TE Connectivity

Product Change Notification: PCN-25-257147

AMPLIMITE HDP-20, HDP-22 CONNECTOR AND CONTACTS

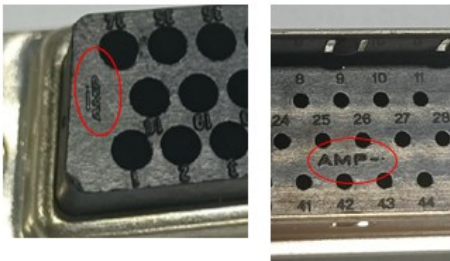
Please be aware of an upcoming cosmetic change to the listed part numbers (not affecting the function of the product). Before: name and logo are mentioned as AMP After: name and logo are mentioned as TE

AMP LOGO and wording on product

TE Logo and wording on product

AMP word on stamped part

TE word on stamped part

New tool is built and to standardize logo, the logo and name on the product is mentioned as "TE"
